630 Boren Ave N Recommendation Meeting #2

West DRB - September 7th, 2016

SDCI# 3022086

Block 25 West

Recommendation #1
View looking Northwest

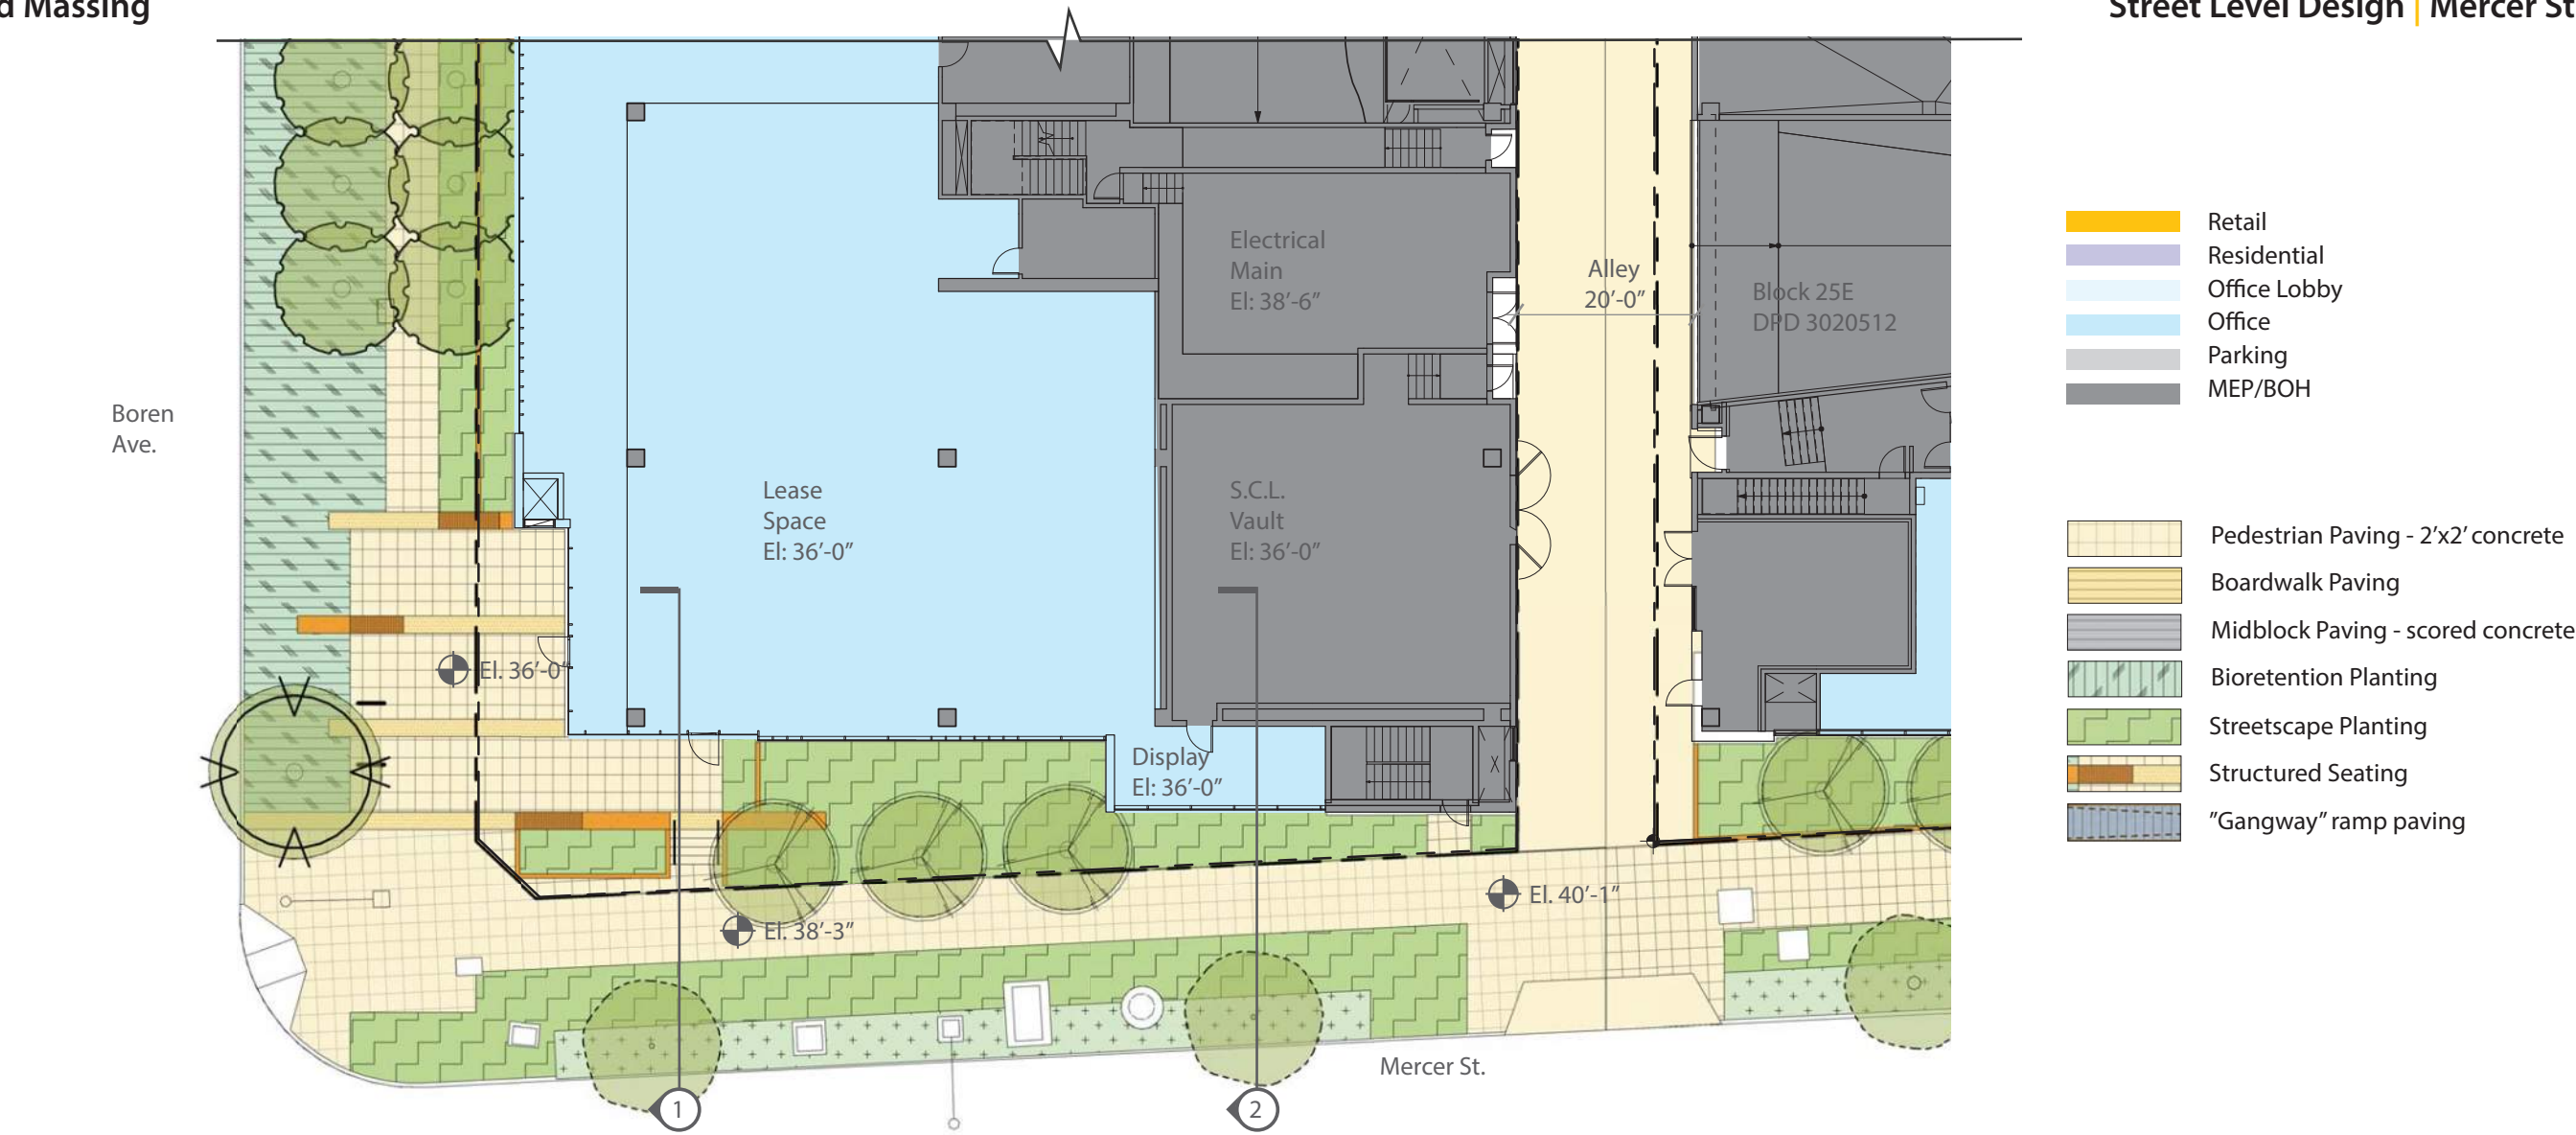
Following are summary comments from DRB Recommendation Meeting #1, July 20, 2016:

1. Block Concept and Massing

- Horizontal tubes exhibit a strong design concept in the three-block waterfront district
- Supported the consistent 2-story scale of the ground floors
- Recommended the eastern tube of the Mercer elevation shift up
- Recommended enhancing the vertical reveal and fin of the north tower

- 1 Elevate south-facing “monitor” on east side of block to introduce visual movement and variety
- 2 Reinforce established language of level 1 and 2 wood “boxes” at SE corner
- 3 De-emphasize stair-stepping of 6th floor massing
- 4 Further differentiate tower massing by emphasizing contrast of the smooth, darker-toned south and est block with the more textural west and north block. See further analysis pages 16-23

Form + Skin Diagram

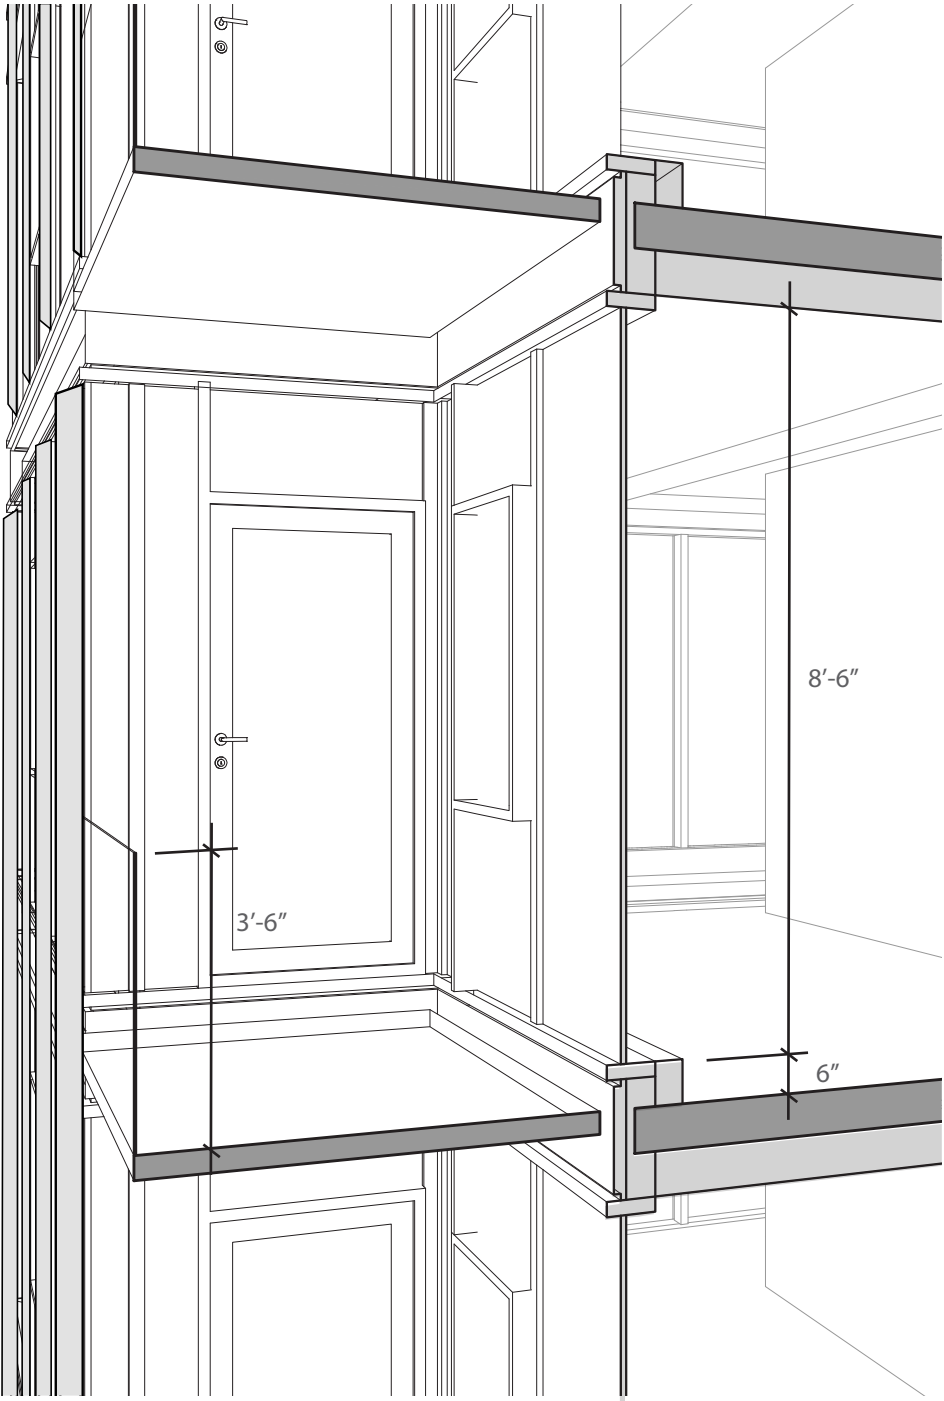
2. Residential Tower Verticality and Composition

- Supported concept of a 'vertical tube' and reinforcing slender, vertical proportions
- Recommended the vertical fins be more pronounced on the north and south facades, and/or the adjacent wall planes be offset, and/or deep, wide reveals be employed, to reinforce verticality
- To ensure verticality, recommended the top floor of windows and balconies be consistent with the floors below
- Recommended the vertical spandrels and fenestration be carried down and through the office floors, to better unify the form

- 3 Amplify vertical fin element to define tower block
- 4 Deemphasize individual floor lines with two-story pattern that visually unifies form
- 5 Knit penthouse level into overall form with pattern overlay
- 6 Maintain spandrel color continuity between residential and office

Street Level Design | Boren Avenue N.

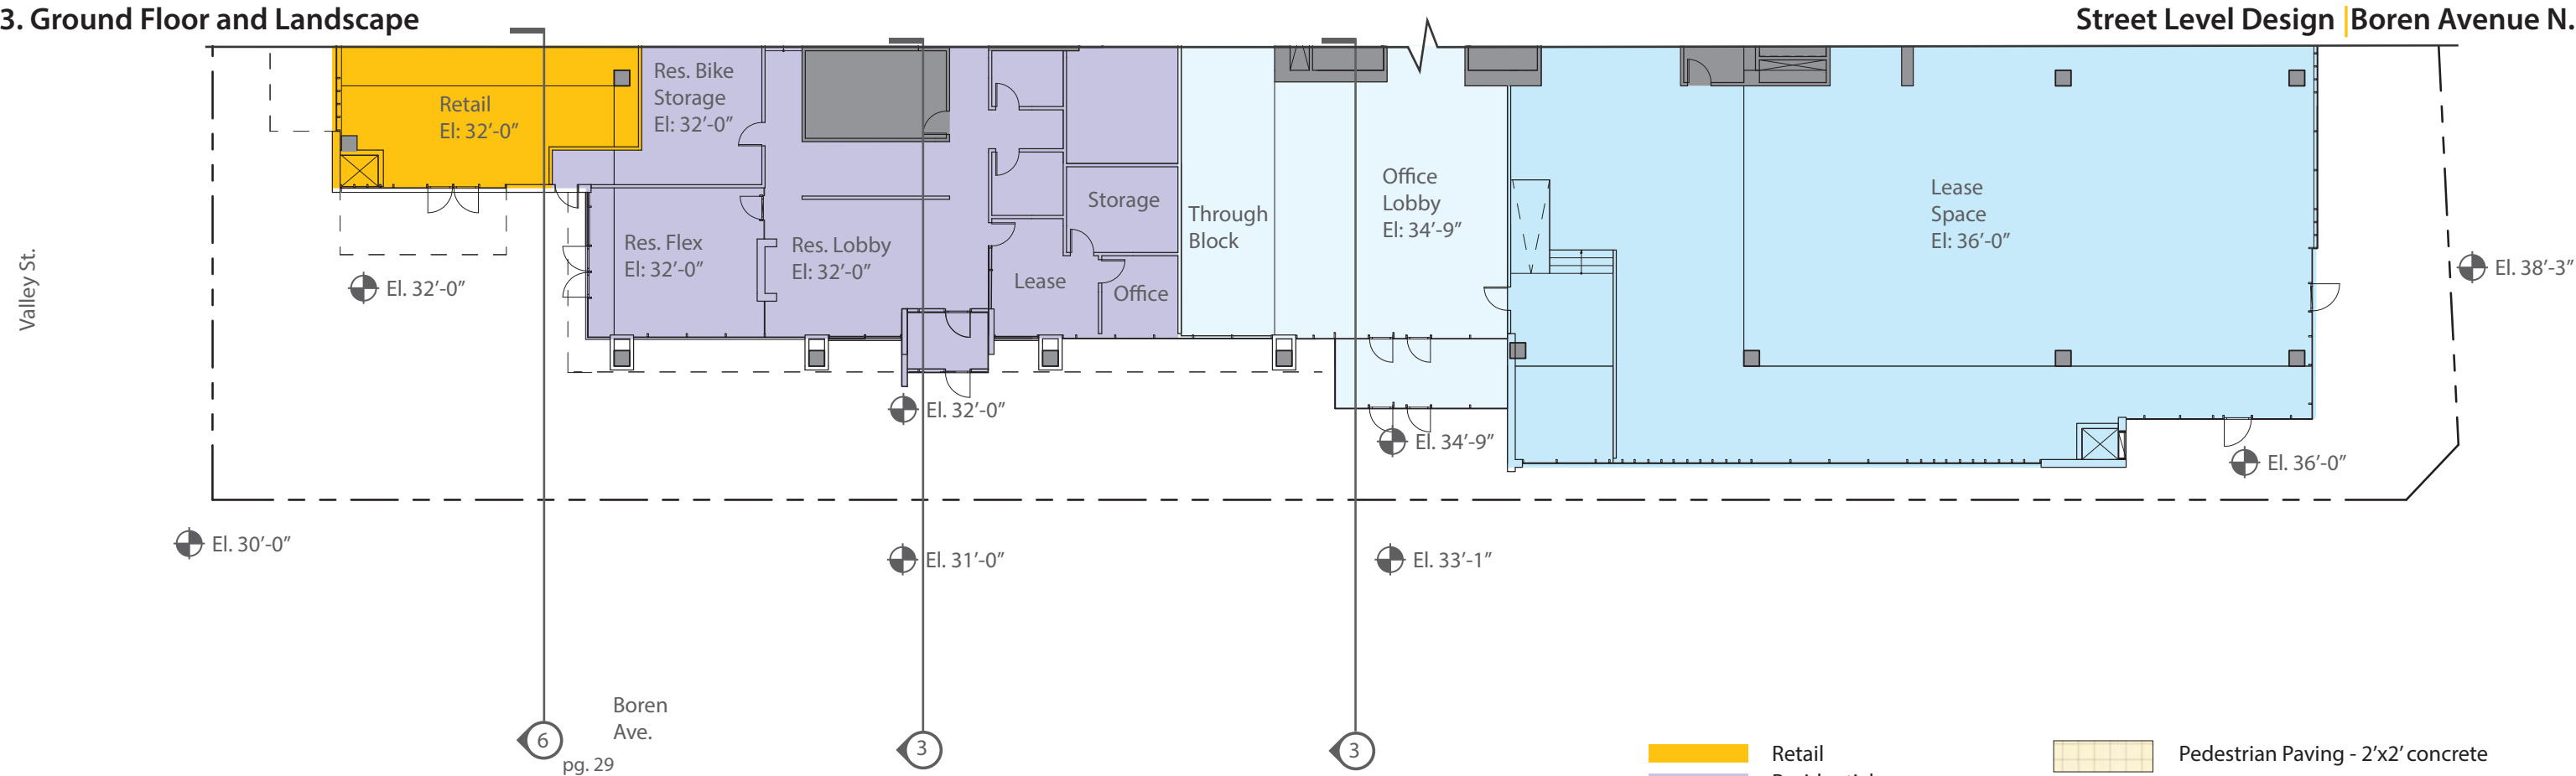
3. Ground Floor and Landscape

- Supported warm, wood cladding proposed at the north, south, and west corners of the ground floor, and the wood liner in the west office portal and lobby
- Recommended a more welcoming residential entrance on the west elevation
- Strongly agreed the elevated boardwalk must be legible and is a key aspect
- Recommended the boardwalk material have a unique color, texture, pattern, and acoustical character
